PLAN COMMISSION

October 8, 2018 @ 5:30 p.m.
COUNCIL CHAMBERS #115
CITY HALL

BLOOMINGTON PLAN COMMISSION
STAFF REPORT
Location: 1550 N. Arlington Park Drive

CASE #: PUD-13-18
DATE: October 8, 2018

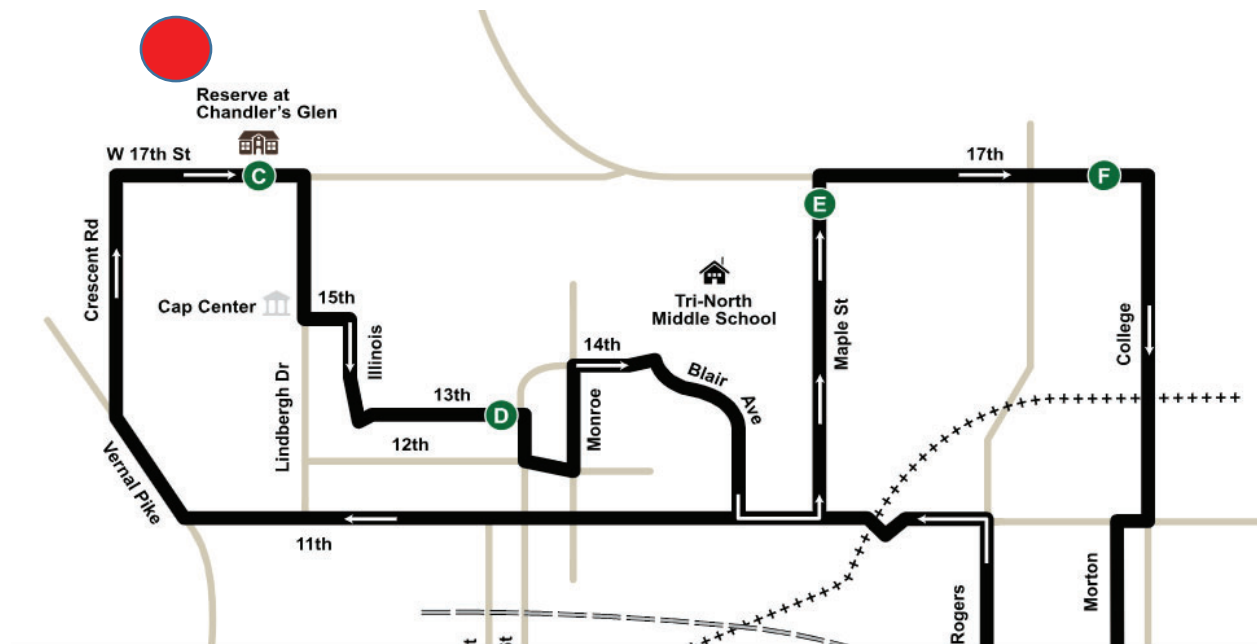
Architecture/Materials: The proposed project will contain a minimum of five (5) building types and two (2) building styles. The designs are intended to reflect a traditional residential neighborhood in the architectural design. The project will meet the anti-monotony standards of 20.05.016. While some type examples were submitted, the Department would like more specific

material standards to be included, as well as more than five building types to meet Comprehensive Plan. This could be alleviated when the developer proposes an underlying zoning district from the UDO to address items not addressed in the PUD documents.

No base zoning was suggested, but the Department recommends the architectural materials standards of the adjoining RS zoning district.

19.) GREENSPACE TO REMAIN

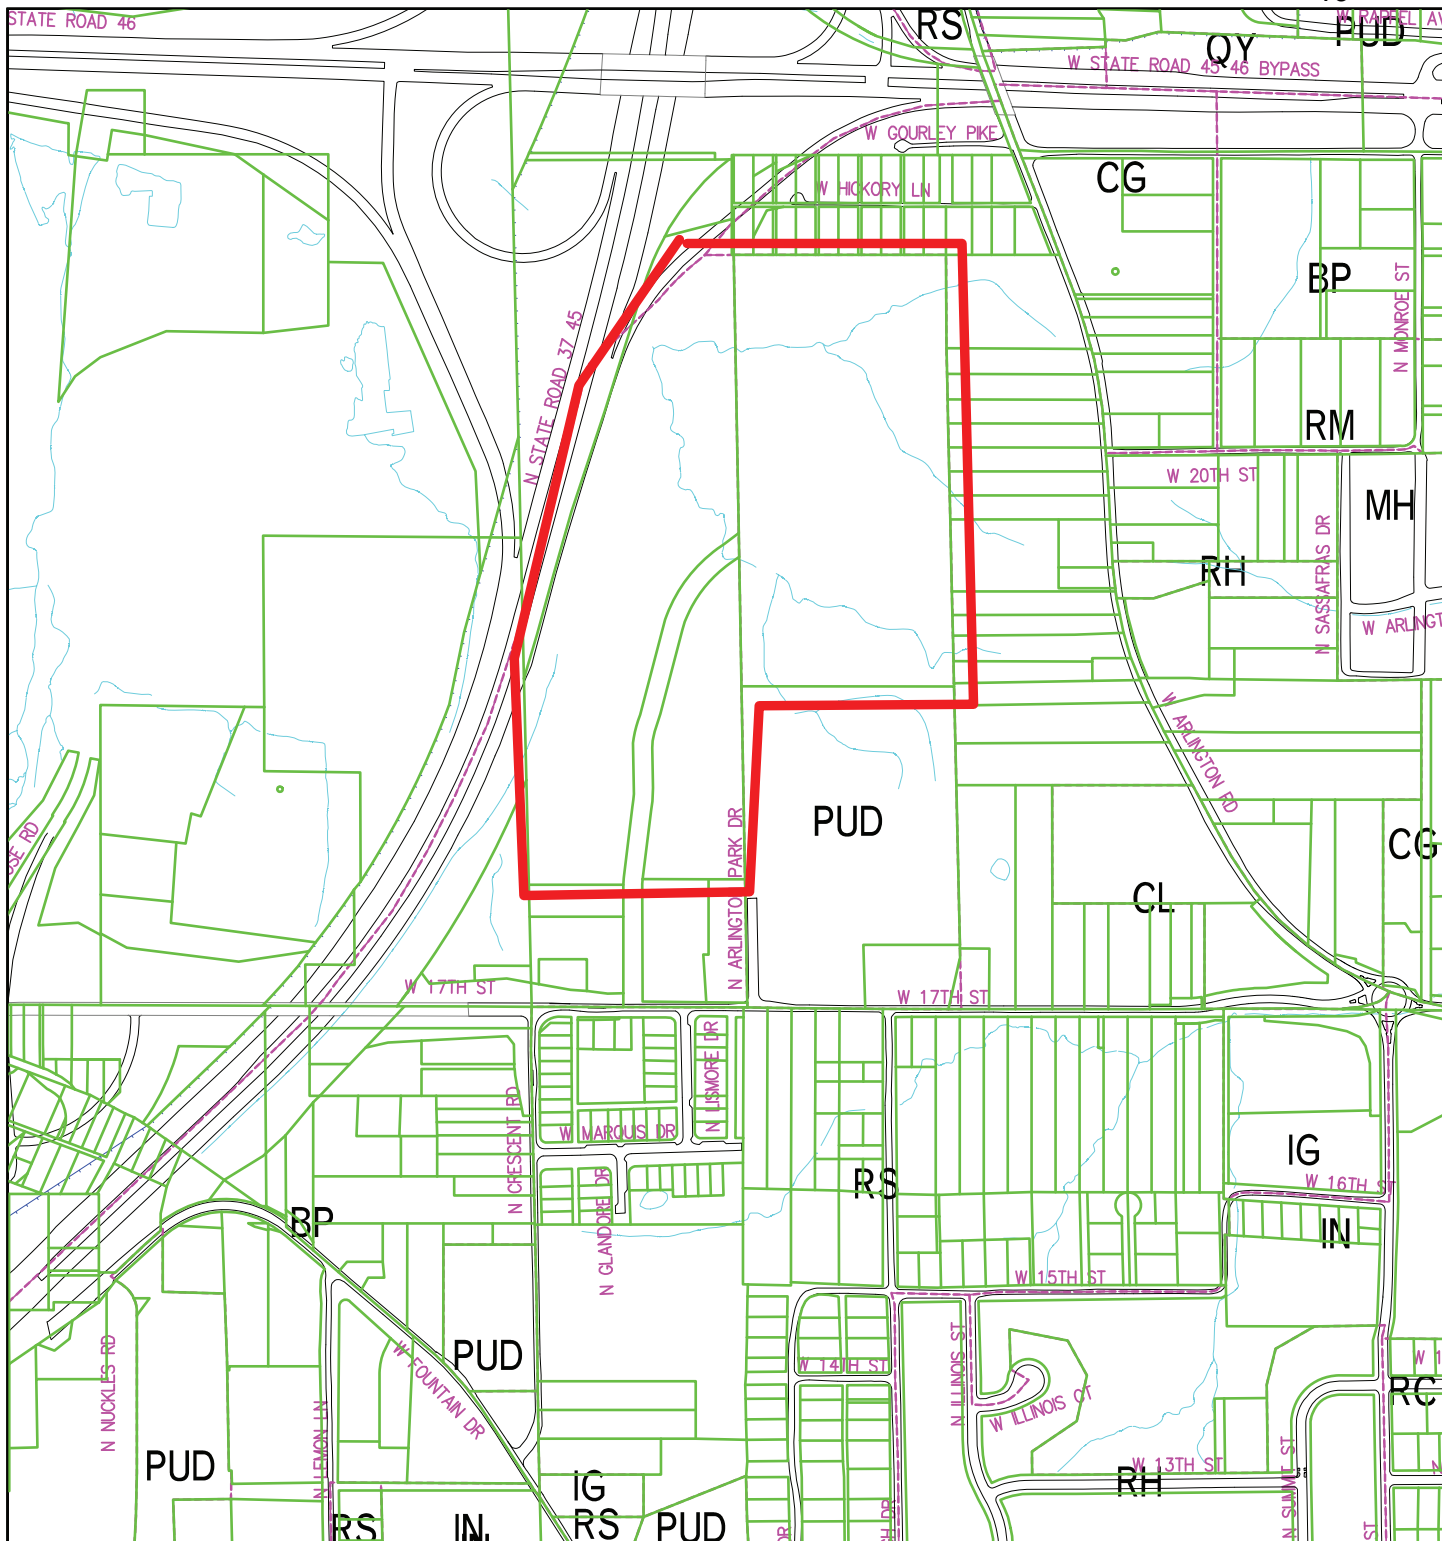
How many acres and what is your definition of green space?

1.) LANDSCAPE PLAN

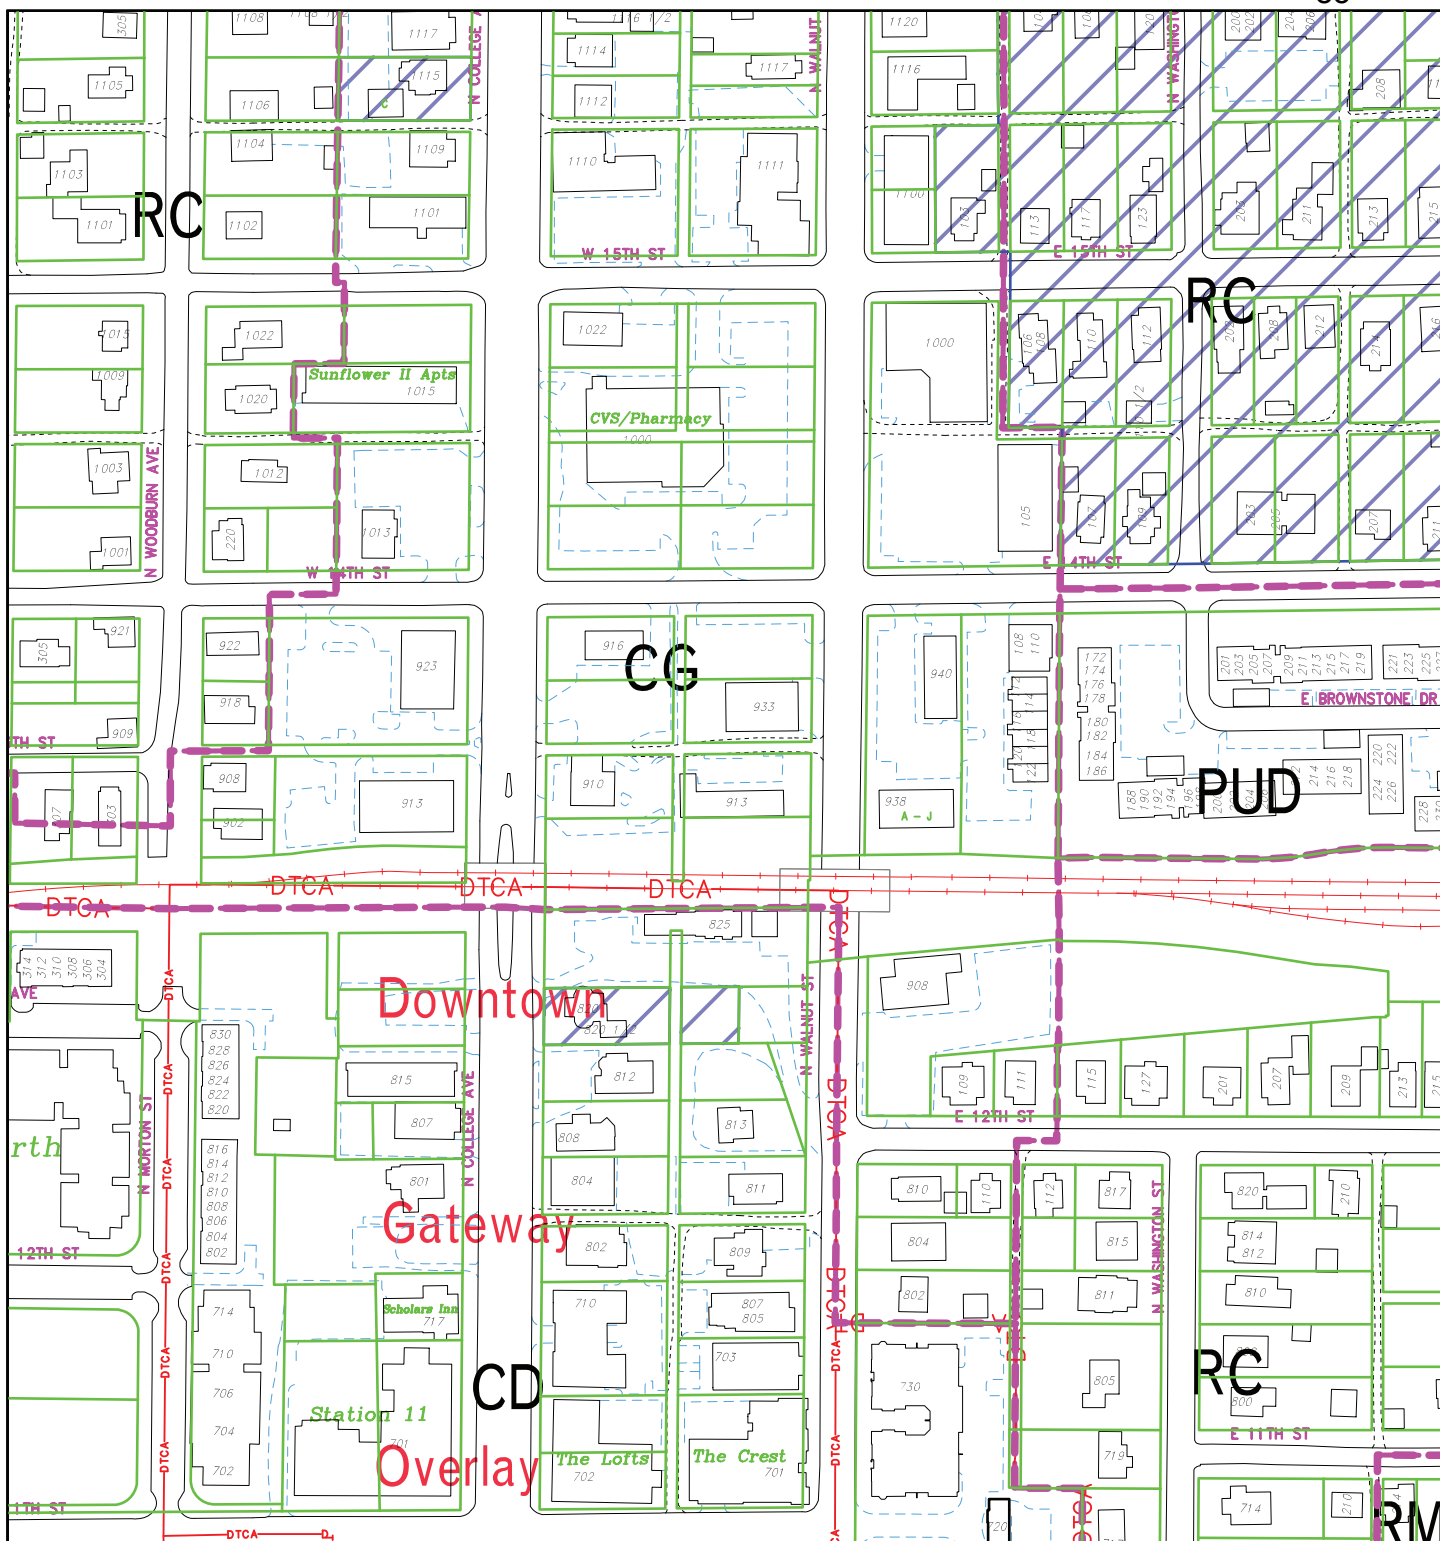
The Landscape Plan will need some revisions. The EC applauds the Petitioner for using mostly native plants on the plan. Native plants provide food and habitat for birds, butterflies and other beneficial insects, promoting biodiversity in the city. Furthermore, native plants do not require chemical fertilizers or pesticides and are water efficient once established.
